AMENDED IN RED
17 JUL 2012
By: BRIANNA EYFFE (name)
of the ULDA

SITE PLAN

PLANS AND DOCUMENTS
referred to in the ULDA
APPROVAL dated 18 / 7 / 2012

Sheet No. 1 / 35
Scale: 1:200
Date: 26 / 06 / 2012
Client: Ring Group Pty Ltd
Address: Lot 16 Bauman Way
Blackwater

East Elevation of Unit 7

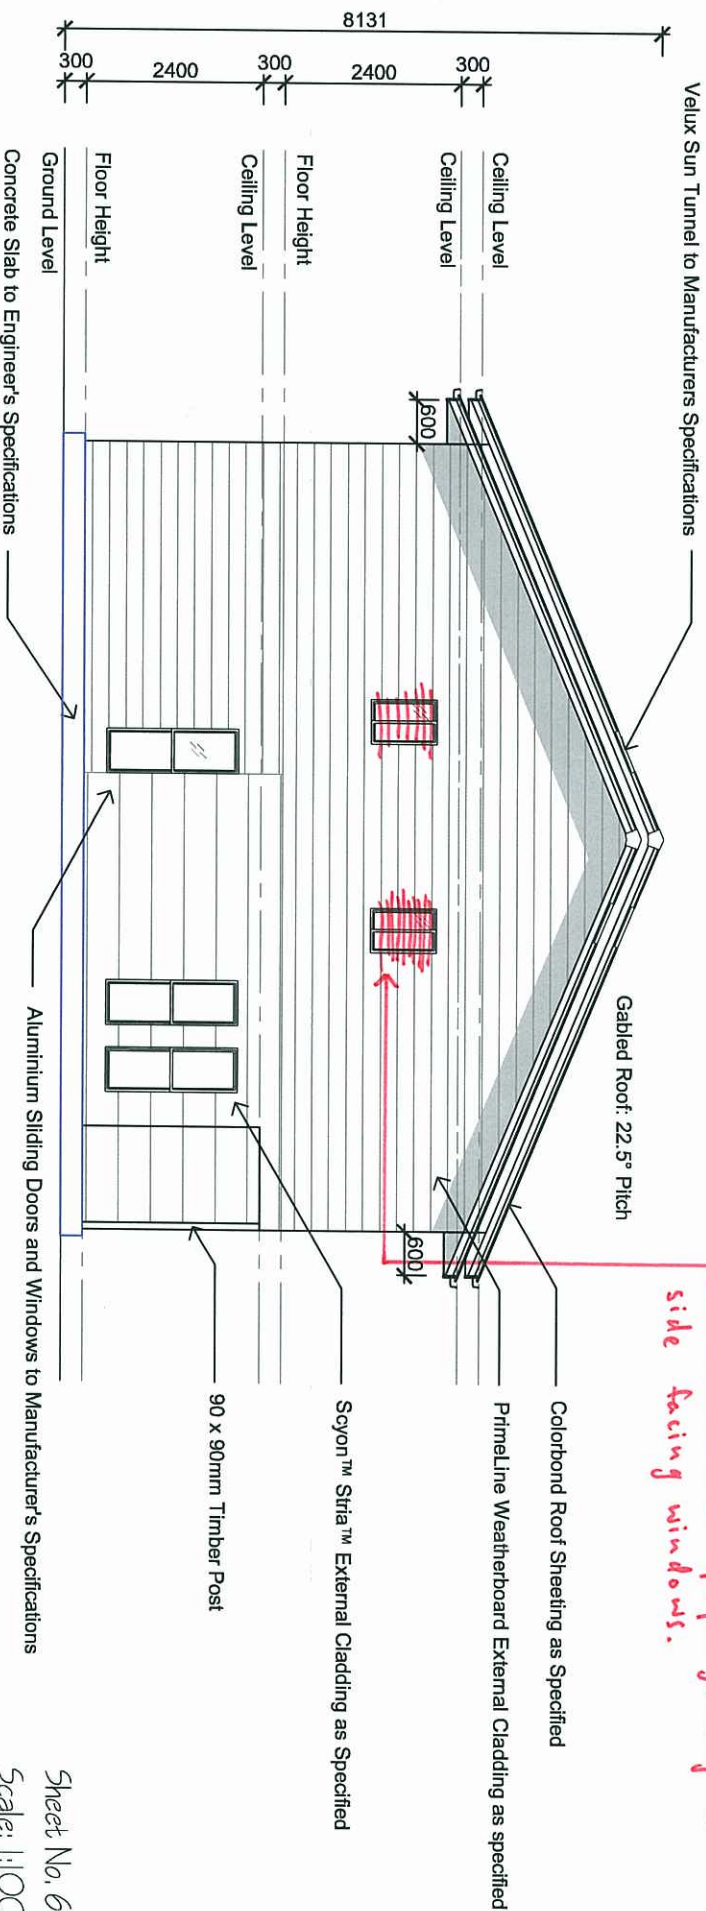
Fix external privacy screens, sill height above 1500mm or opaque glazing to side facing windows.

East Elevation of Unit 3

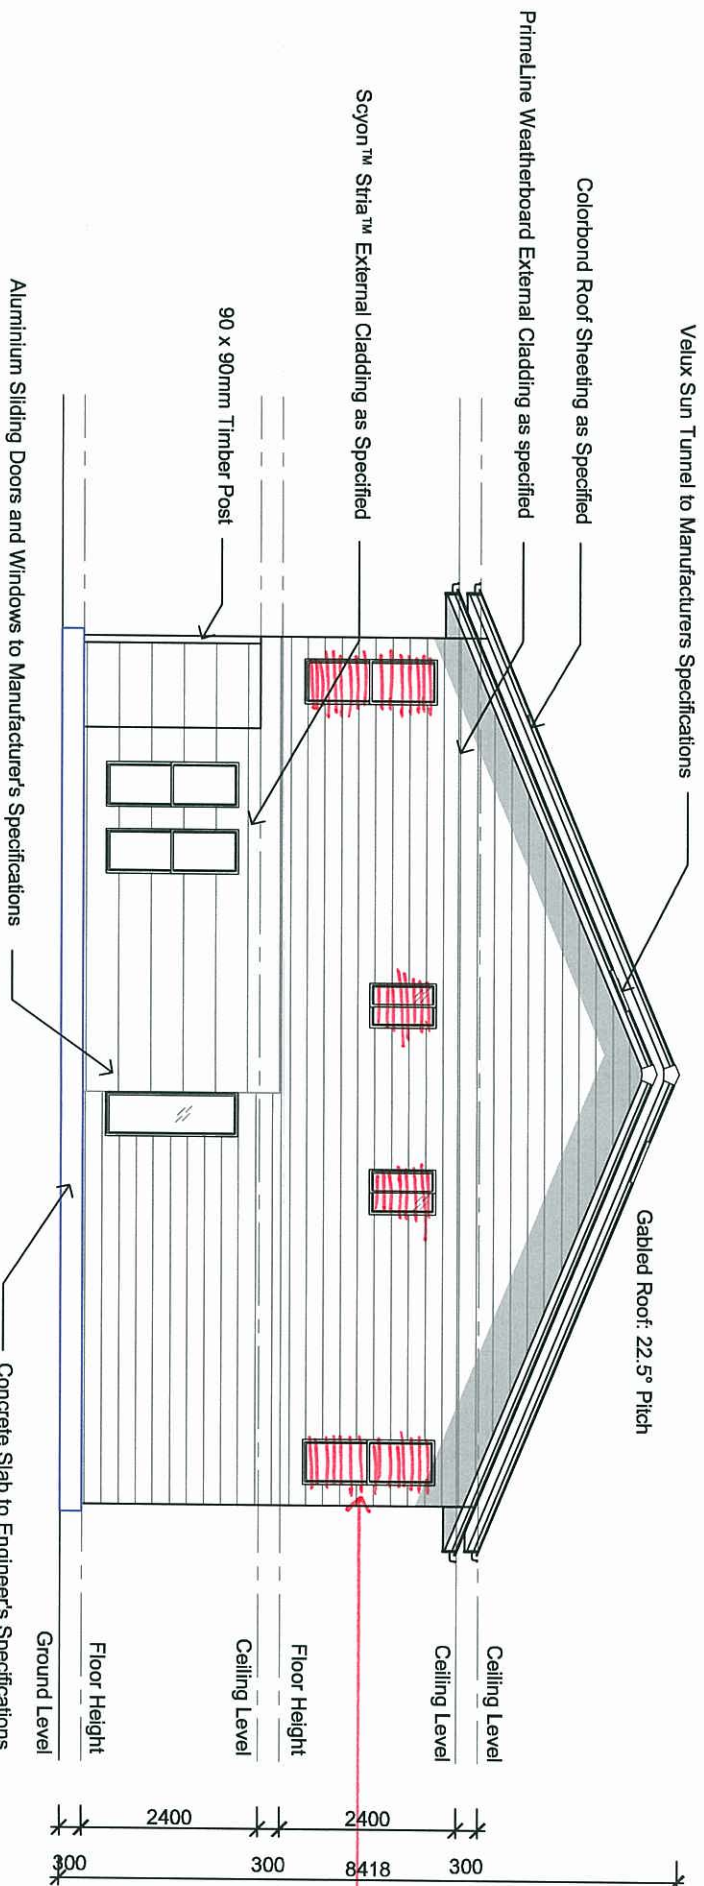
Fix external privacy screens, sill height above 1500mm or opaque glazing to side facing windows.
